RE: **STAFF SUMMARY REPORT**
LSDP – DODSON POINTE APARTMENTS

PROJECT NAME:	Dodson Pointe Apartments
PROJECT DESCRIPTION:	240 apartment units on 20.2 acres
ADDRESS/LOCATION:	6000 W Stoney Creek Drive
GROSS SITE AREA:	20.2 acres
RESIDENTIAL UNITS:	240 total units, 11.88 units per acre
REQUESTED WAIVERS:	Curb Cut Separation, Street Improvements, Connectivity
REQUESTED VARIANCES:	Setback Reduction
FEES-IN-LIEU:	Fee In-Lieu of Street Improvements along Dodson (TBD)

RE: Large Scale Development
Dodson Pointe Apartments

Re: Conditional Approval of Civil Plans
Dodson Pointe Apartments

UTILITY PLAN
DODSON POINTE APARTMENTS
ROGERS, ARKANSAS

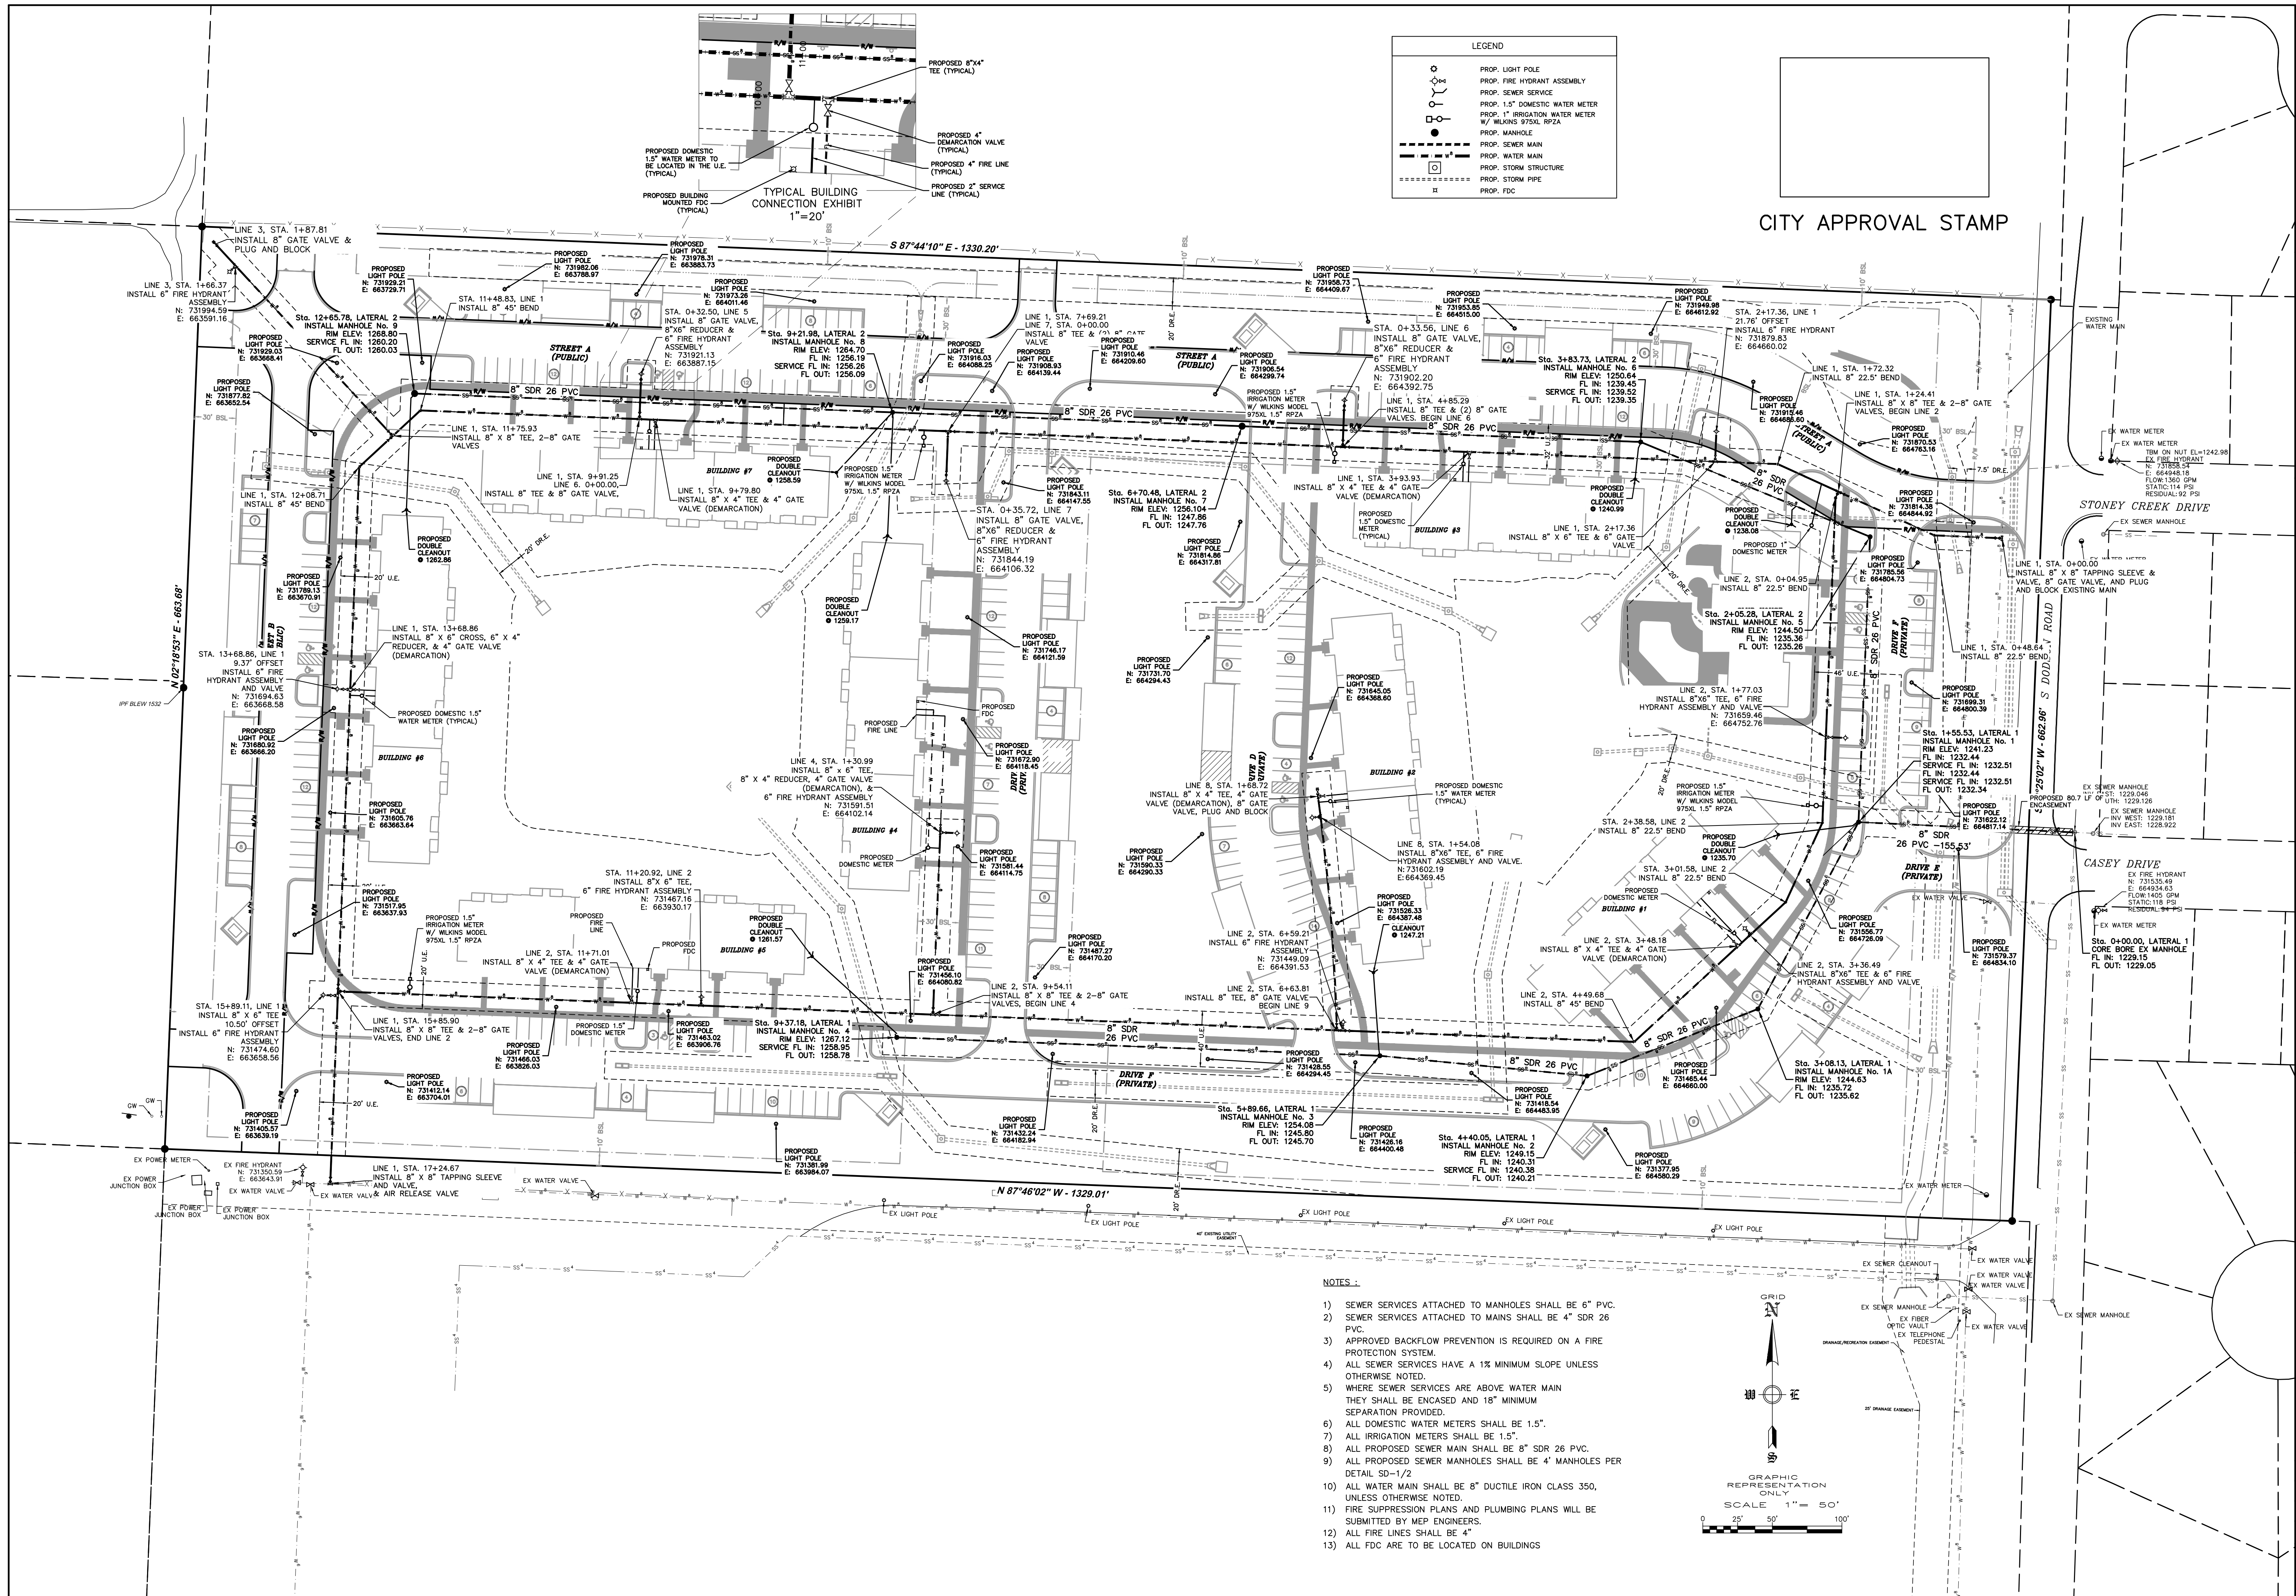
1. Make the connection for the sanitary sewer service for Building #2 at Manhole 3 on Lateral 1 instead of at Manhole 2. There should be enough separation between the water main and sewer service to eliminate the need for sewer encasement.
